## Obsolescence of Series SPD74 / Last Time Buy Notification

**Description of Change:** API Delevan announces the end of life for Product Series SPD74.

**Replacement Series:** [HRSPD74](#)

#### HRSPD74

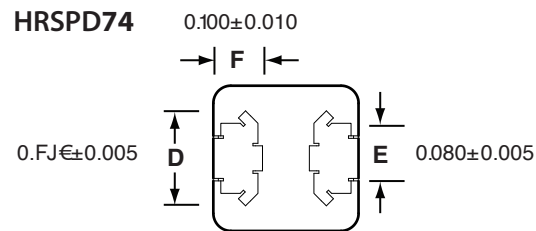
**SPD74** Height Dimension 'C'  
0.185 Inches Max (4.7 mm Max)

**SPD74** Terminal Dimensions  
0.088 ± 0.020 'E' (in) by 0.042 ± 0.020 'F' (in)

**HRSPD74** Height Dimension 'C'  
0.198 Inches Max (5.03 mm Max)

**HRSPD74** Terminal Dimensions  
0.190 ± 0.005 'D' (in) by 0.100 ± 0.010 'F' (in)
